Re: Indian Point Unit No. 2  
Docket No. 50-247

LWR PRIMARY COOLANT SYSTEM  
PRESSURE ISOLATION VALVES

Consolidated Edison Company of New York, Inc.  
Indian Point Unit No. 2  
Docket No. 50-247  
March, 1980

FIGURE 1 : INDIAN POINT 2

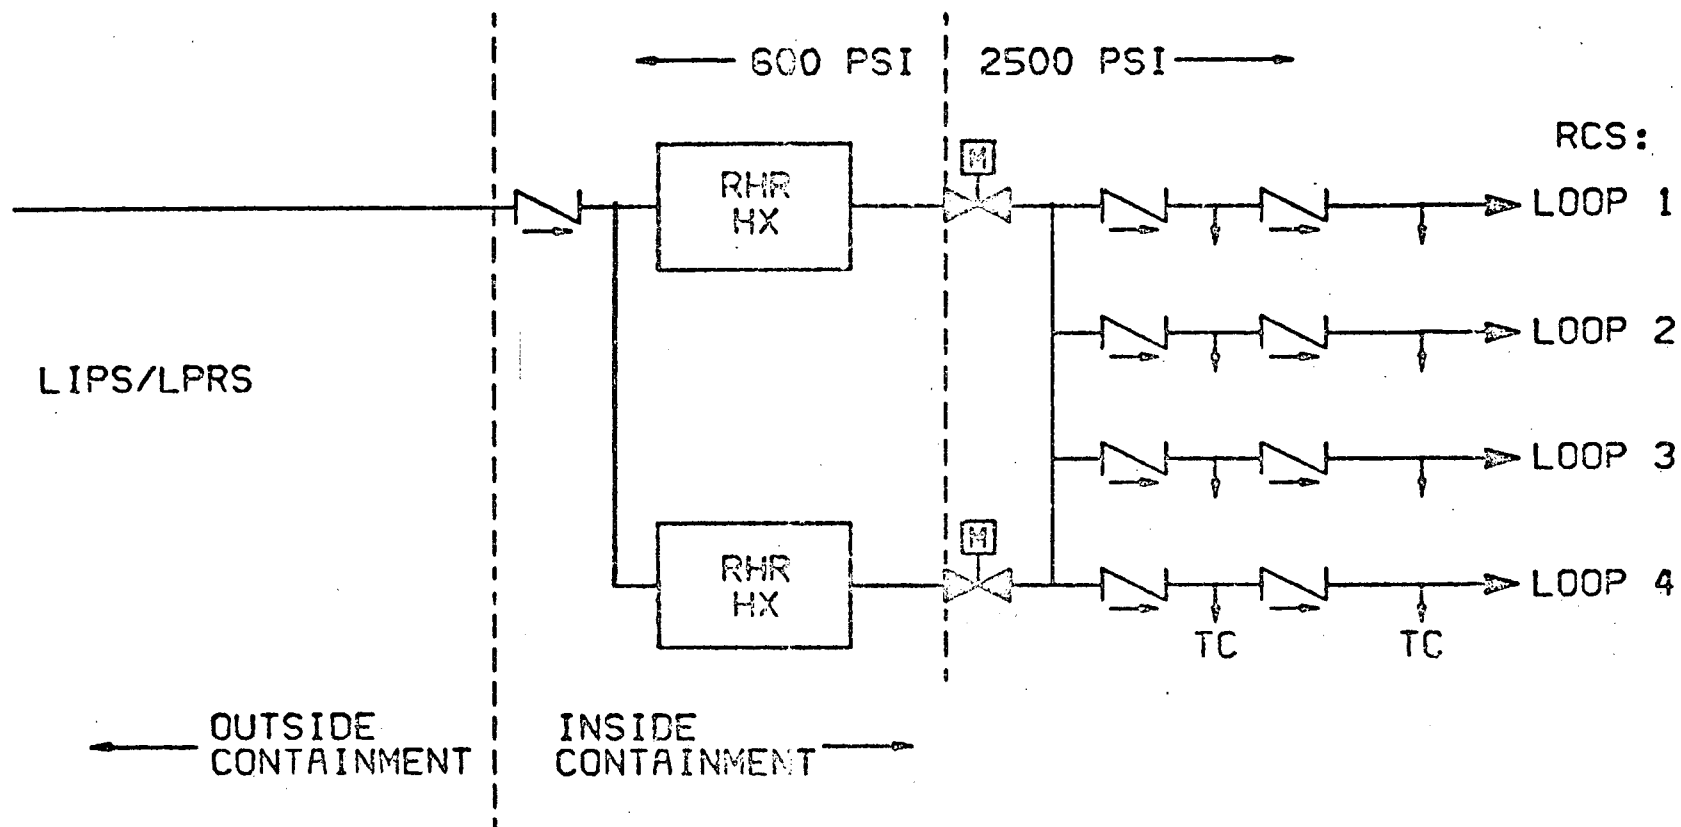
Describe the valve configuration at your plant and indicate if an Event V isolation valve configuration exists within the Class 1 boundary of the high pressure piping connecting PCS piping to low pressure system piping; e.g., (1) two check valves in series, or (2) two check valves in series with a MOV;

The piping arrangement between the Low Pressure Injection System and the Reactor Coolant System for Indian Point 2 is shown on Figure 1. As can be seen, the 600 psi and 2500 psi piping are separated by two check valves and a normally closed motor-operated valve. The system sketched on Page V-58 of WASH-1400 is similar insofar as check valve arrangement is concerned. A difference of fundamental importance is that the 2500 psi and 600 psi systems in Indian Point Unit 2 are separated by a normally closed motor-operated valve. Thus, check valve failure is meaningful only if the motor-operated valves are mispositioned. Another important difference is that much of the 600 psi piping in Indian Point 2 is inside containment; in the WASH-1400 system the interface between 2500 psi and 600 psi piping is outside containment. Additionally Indian Point 2 has a check valve in the 600 psi piping inside containment just prior to the containment penetration. For these reasons, a double check valve failure (assuming the motor-operated isolation valve to be incorrectly open) would probably only result in rupture of 600 psi piping inside containment with blowdown also inside containment.

Check valve testing is another important difference from the WASH-1400 Study. Indian Point 2 has test connections which permit verification of both check valves in the line to each loop.

The Event V, WASH-1400, scenario also is very conservative in that it neglects the possibility of terminating blowdown by successful closure of the motor-operated valve at the boundary between 2500 psi and 600 psi piping.
